SERVICE BULLETIN

SERVICE BULLETIN NO. 210

Kodak M35, M35A, M35-M and M35A-M X-Omat PROCESSORS Kodak Industrex PROCESSORS, Models M35 and M35-A

Modification to the DETECTOR CROSSOVER ASSEMBLIES

New DETECTOR CROSSOVER ASSEMBLY 5B6163

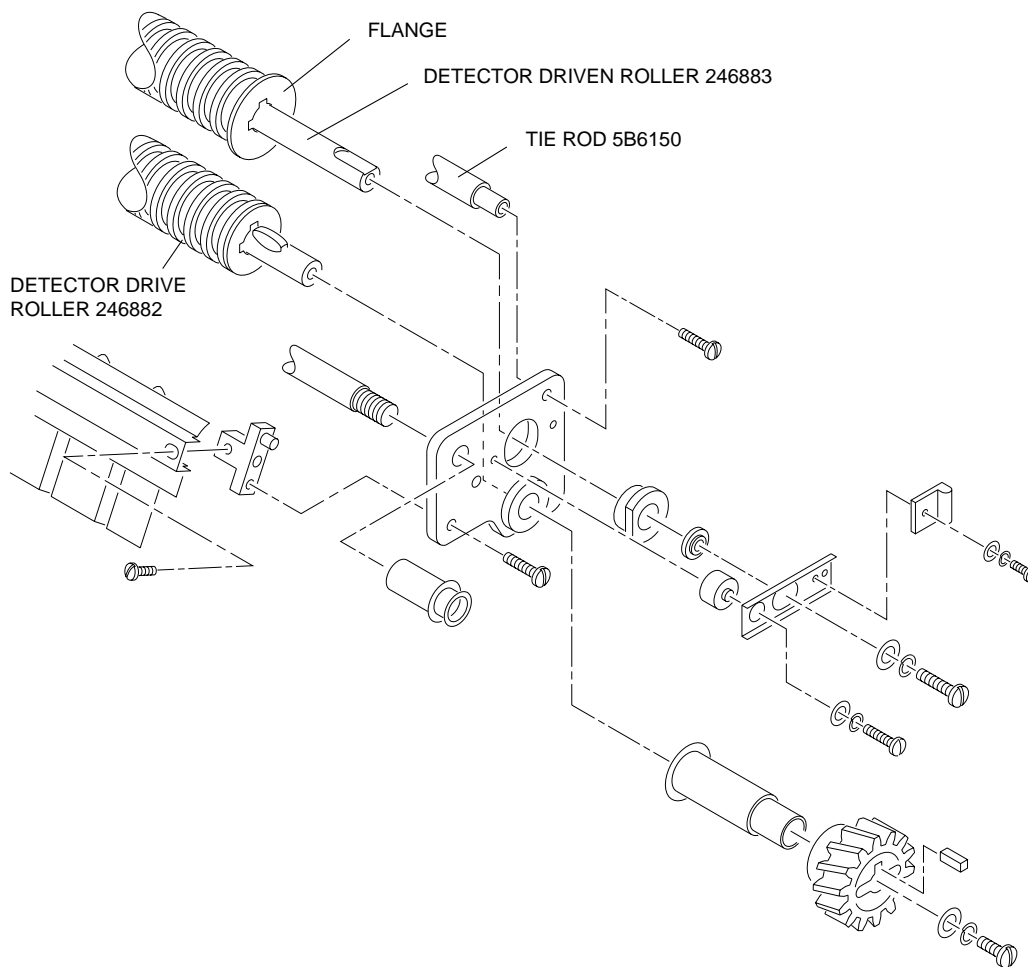
Starting in October 1994, the M35 Series PROCESSORS with the following serial numbers will have a different DETECTOR CROSSOVER ASSEMBLY, Part No. 5B6163.

- The DETECTOR DRIVE ROLLER and the DETECTOR DRIVEN ROLLER have been interchanged. The new part numbers are as follows:
 - DETECTOR DRIVE ROLLER - 246882
 - DETECTOR DRIVEN ROLLER - 246883
- A new TIE ROD **5B6150** will replace the existing TIE ROD 287035 and will allow more clearance between the FLANGE on the DETECTOR DRIVEN ROLLER 246883 and the TIE ROD.

Do not install DETECTOR CROSSOVER ASSEMBLIES 333794, made for PROCESSORS manufactured before October 1994, in PROCESSORS with serial numbers higher than those in the table above. The new DETECTOR CROSSOVER ASSEMBLY 5B6163 is adaptable to all M35 Series PROCESSORS.
